TE Connectivity

Product Change Notification: P-22-023056

Modular jack connector

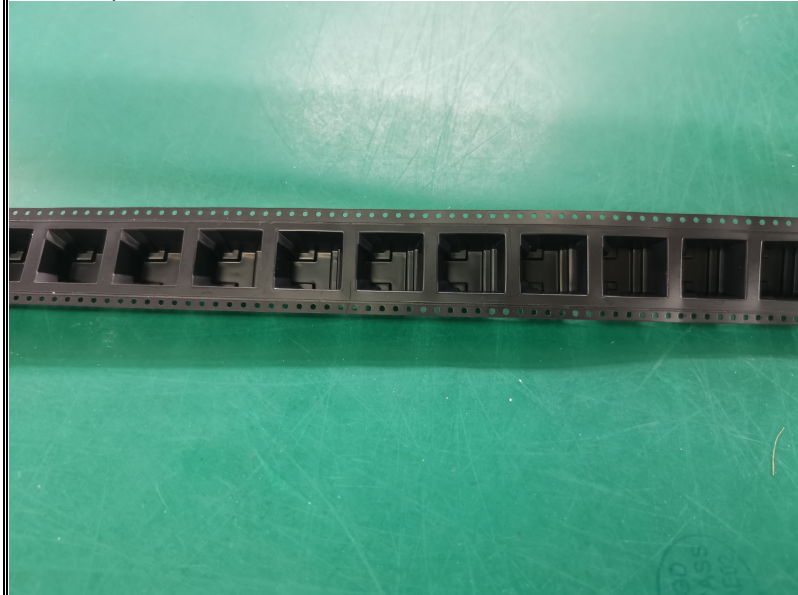
Changing Black tape to Transparent tape

current tape

new tape
